ADDENDUM - R1 CUY-090-18.72

CUY-090-18.72

RESURFACING THE EAST SHOREWAY (IR-90) FROM EAST OF THE INNERBELT CURVE TO EAST 55TH STREET IN THE CITY OF CLEVELAND.

CONCRETE BARRIER REPLACEMENT DETAILS DAB 10-24-22

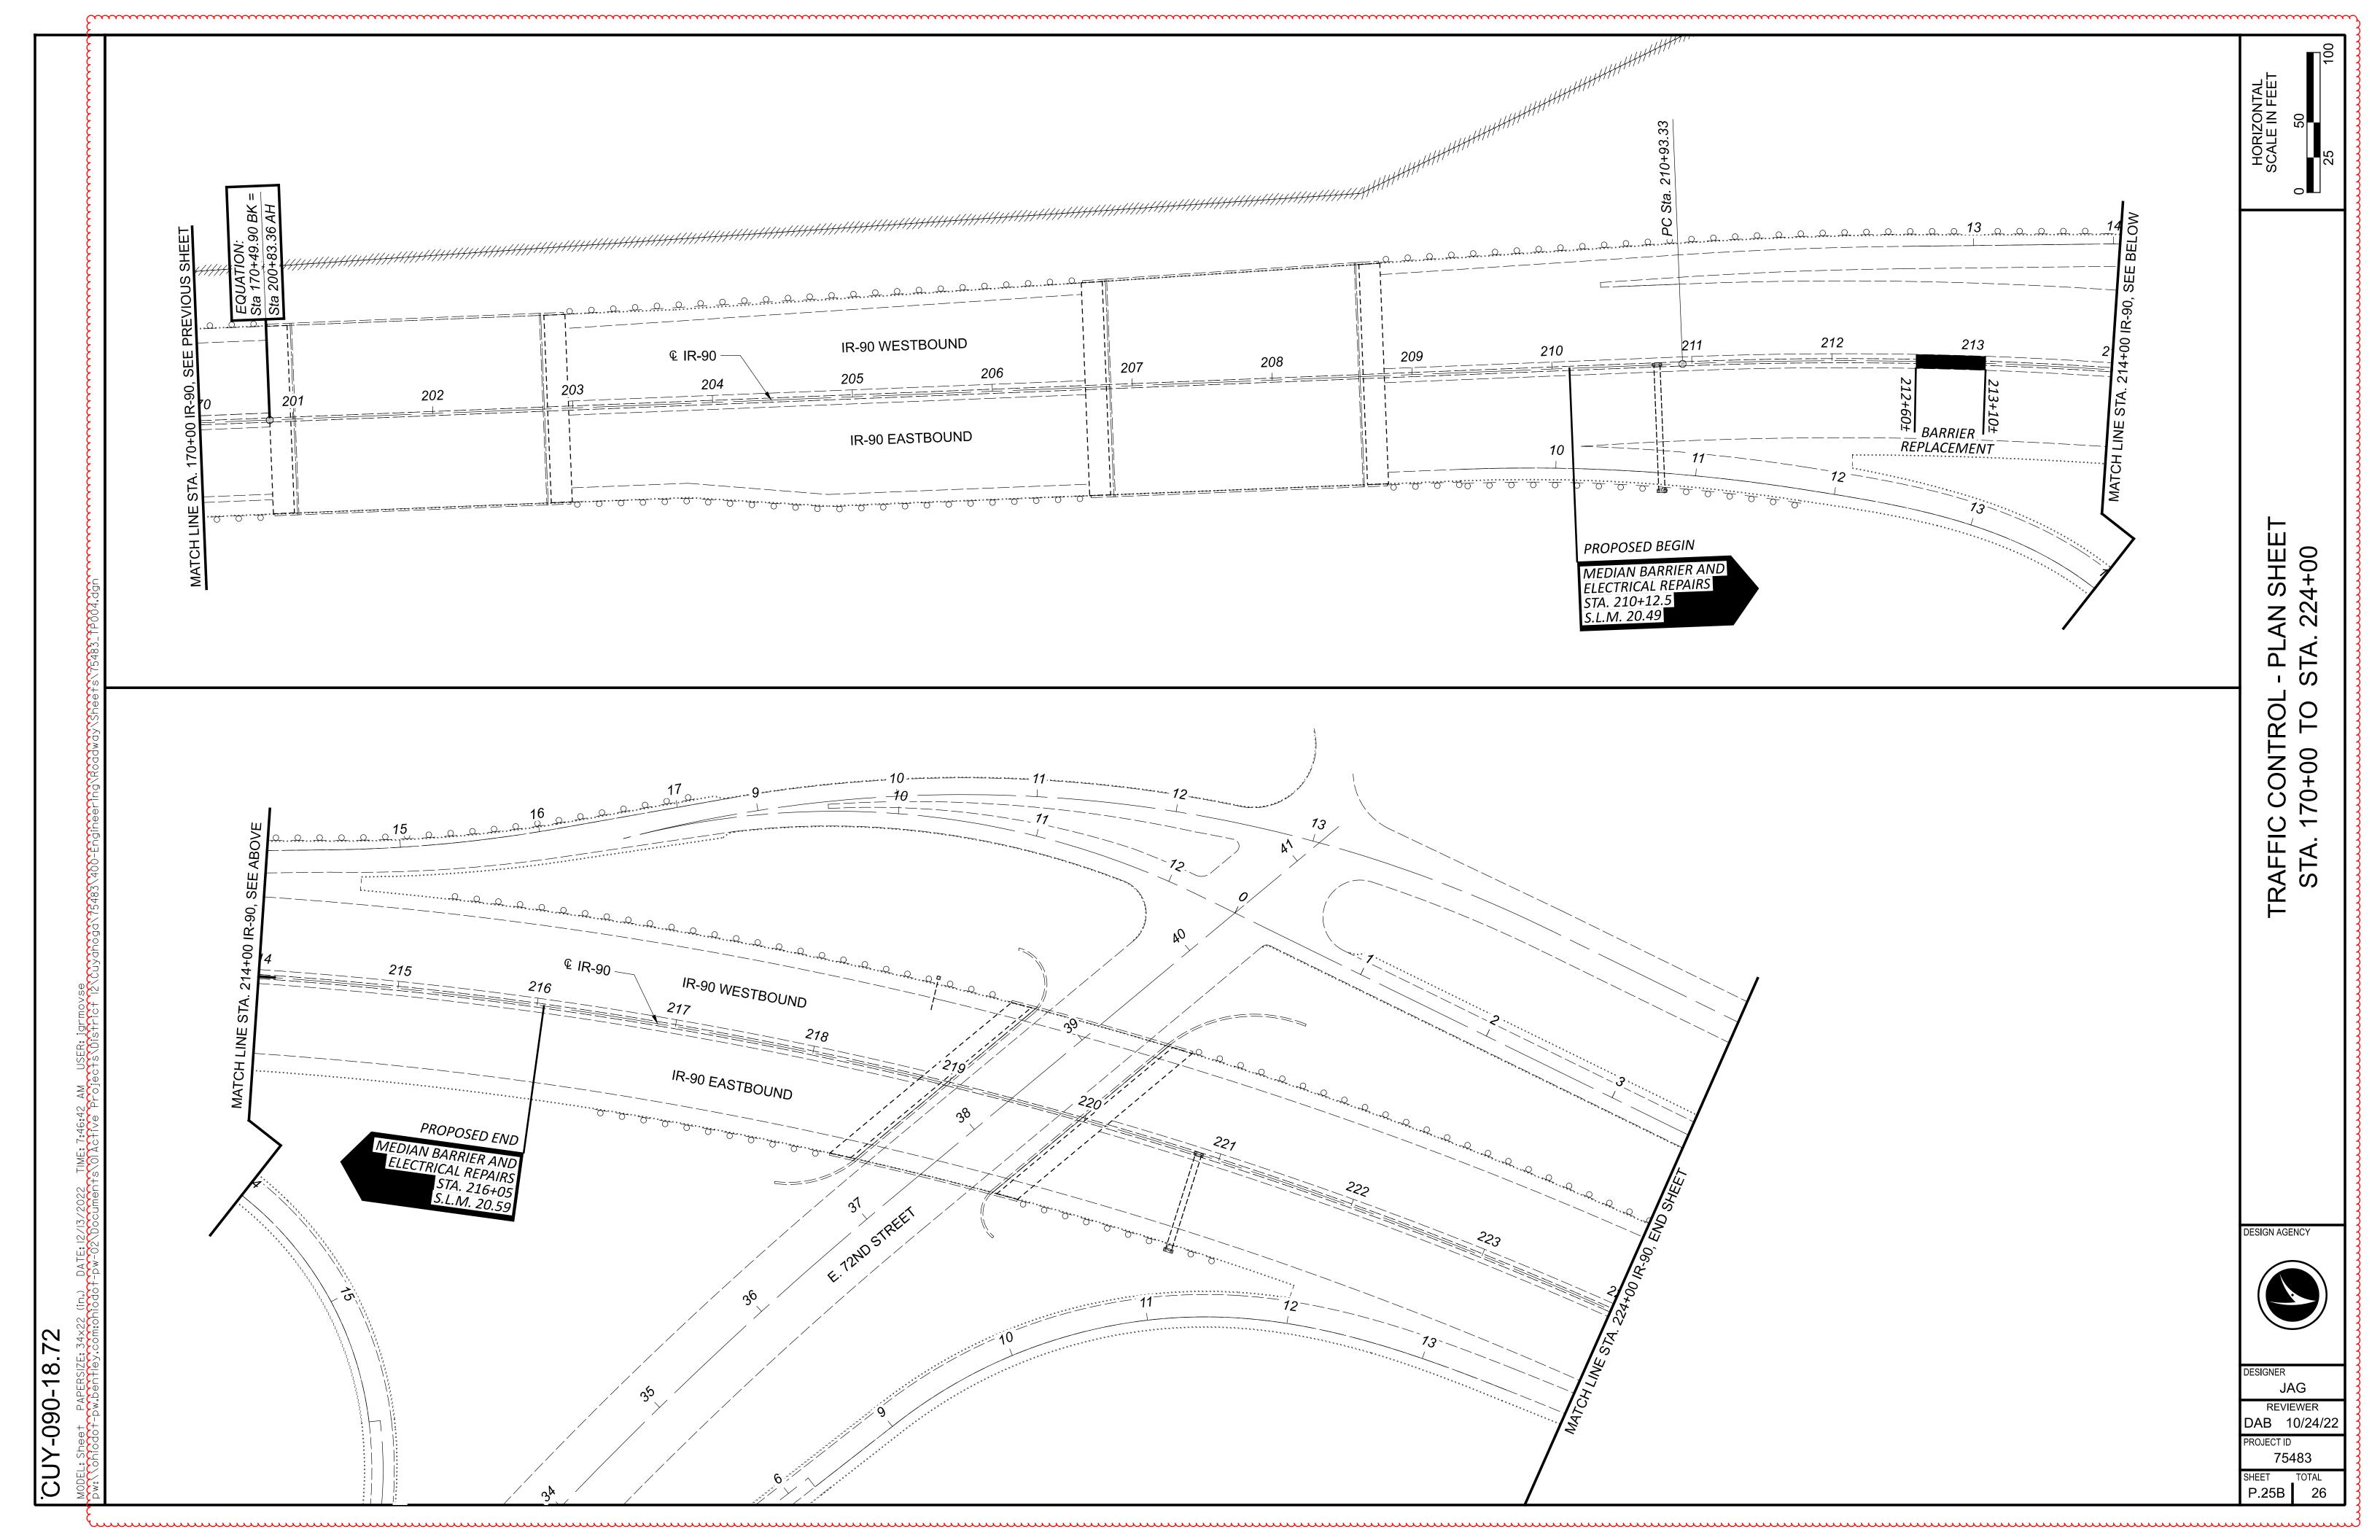
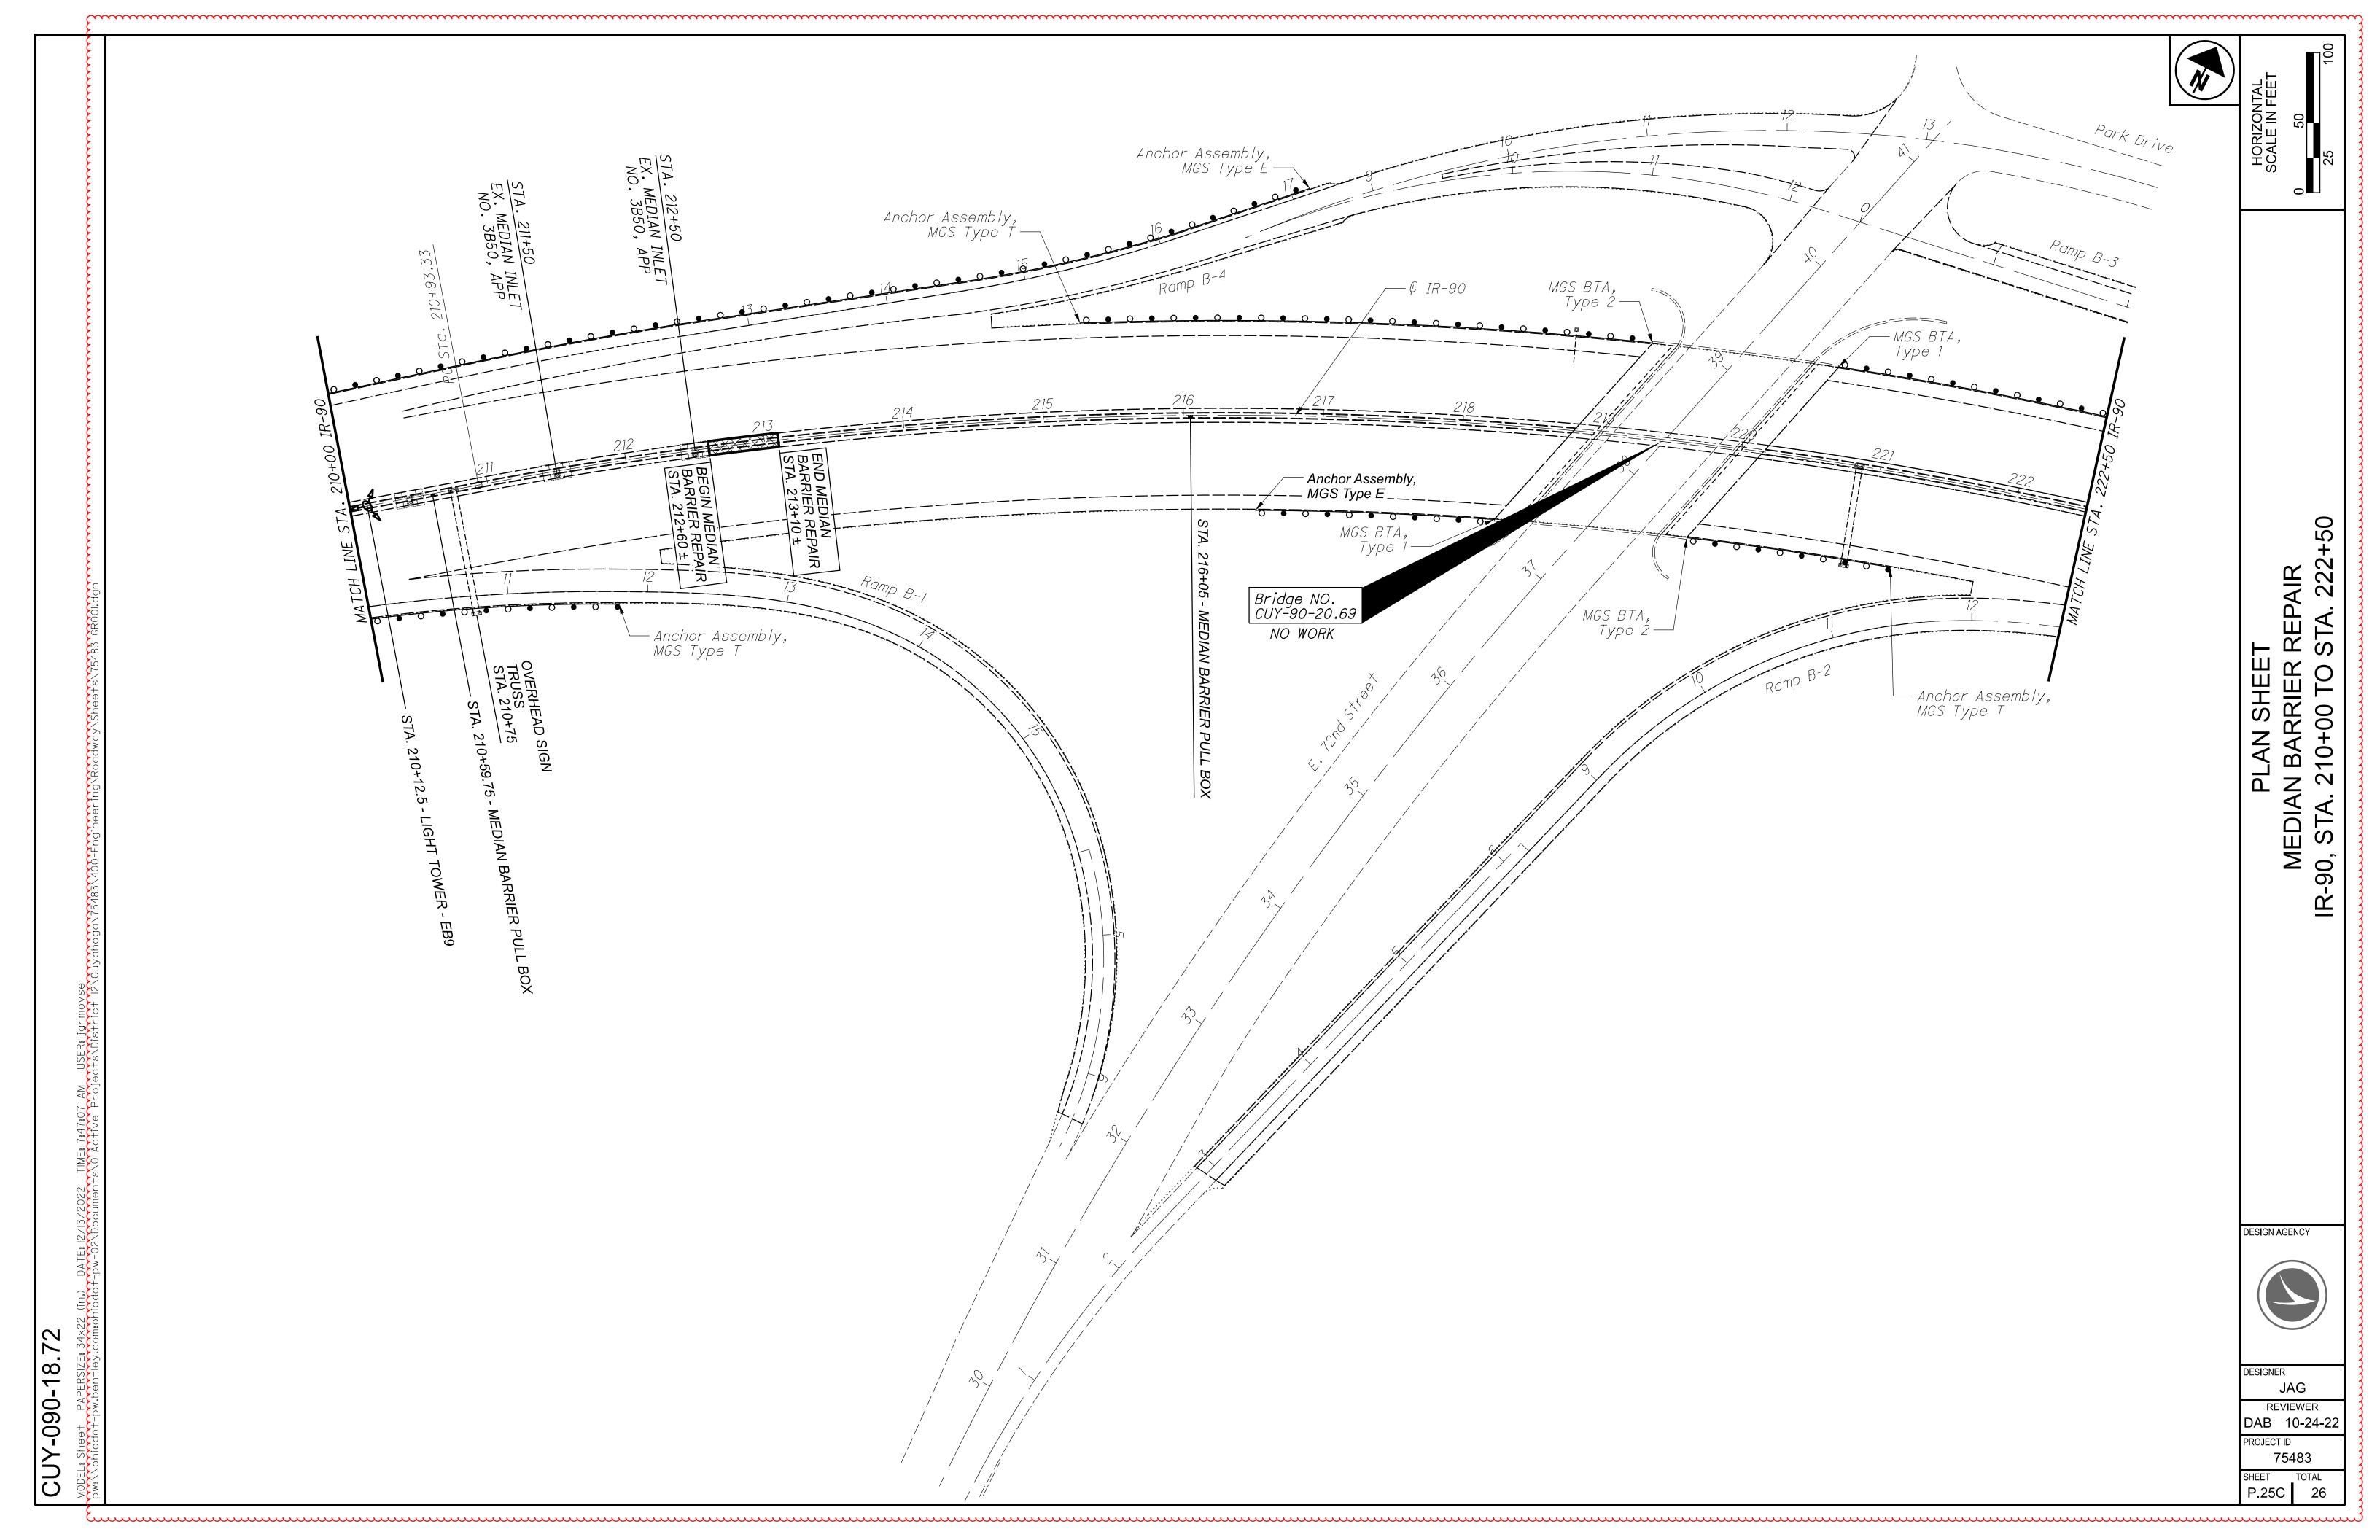
This item shall consist of furnishing and installing Type B50 Concrete Barrier according to the details shown on P.25D of this plan with the following modifications:

- 1. Install the no. 8 dowel bars between the concrete foundation and the concrete barrier. The size, length and placement of the dowel bars shall follow the doweling details shown for the 53" normal sections.
- 2. The cost of the min. 9" thick. 3.5' wide foundation shall be included in this
- 3. For vertical wall butt joints, install epoxy coated 3/4" dowel bars 18" long along perimeter of wall at 12" spacing to tie into existing wall sections.
- 4. Conduit material shall meet the requirements of 725.04 or 725.051. The appropriate couplings shall also be included in this pay item.
